D3290-041 REPLACEMENT WINDOW ASSEMBLY

DRAWING NO. D3290	TITLE REPLACEMENT WINDOW ASSEMBLY	REV. C	DART AEROSPACE LTD ENGINEERING ORDER		D.E.O. NO. D3290-C-1	SHEET NO. SHEET 1 OF 1	SCALE NTS
DRAWN 90	CHECKED b	MFG. APPR. E	APPROVED MP		DE APPR. H		
DATE 09.09.18	DATE 09.09.18	DATE 09.09.18	DATE 09/09/21		DATE 09/09/21

CHANGE MATERIAL THICKNESS OF D3290-1 FRAME TO 0.063 FROM 0.040. REF PAR 09-033.

D3290-1 FRAME

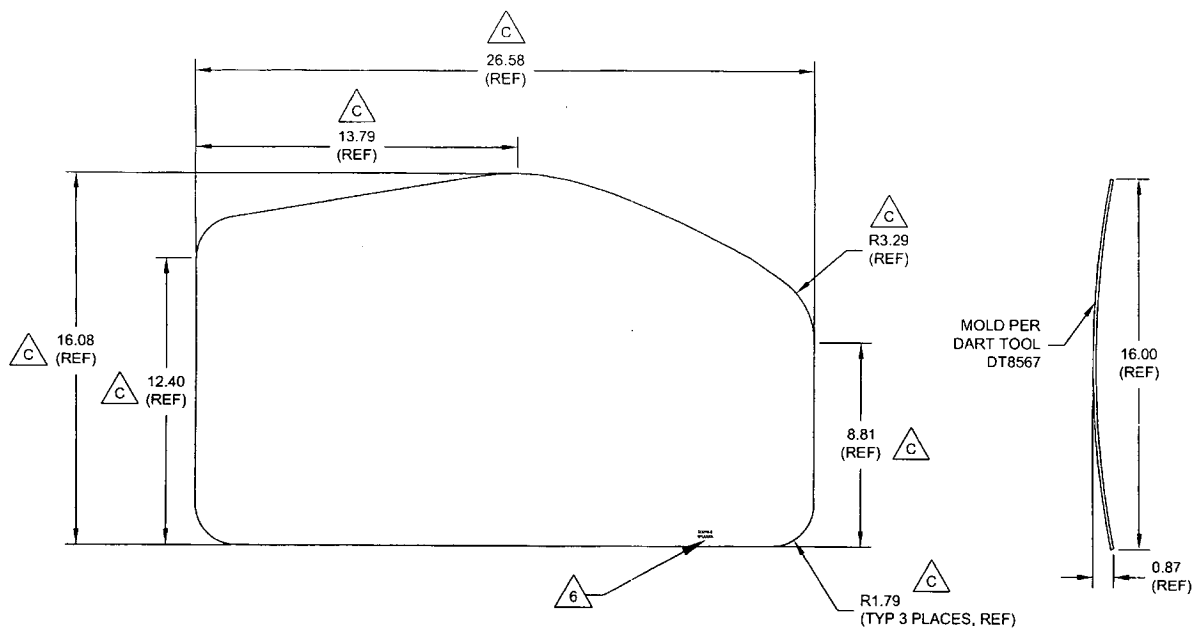
MATERIAL CALL-OUT OF D3290-1 FRAME ON SHEET 1 IS AMENDED AS FOLLOWS:

- 1) MATERIAL: 6061-T6 (OR 6061-T62) ALUMINUM SHEET ~~0.040 THICK~~ 0.063 THICK (REPLACE)
PER AMS-QQ-A-250/11 OR AMS 4025 OR AMS 4027
(REF. DART SPEC. M6061T6S.040) REF. DART SPEC. M6061T6S.063 (REPLACE)
OR
5052-H32 ALUMINUM SHEET ~~0.040 THICK~~ 0.063 THICK (REPLACE)
PER AMS-QQ-A-250/8 OR AMS 4016
(REF. DART SPEC. M5052H32S.040) REF. DART SPEC. M5052H32S.063 (REPLACE)
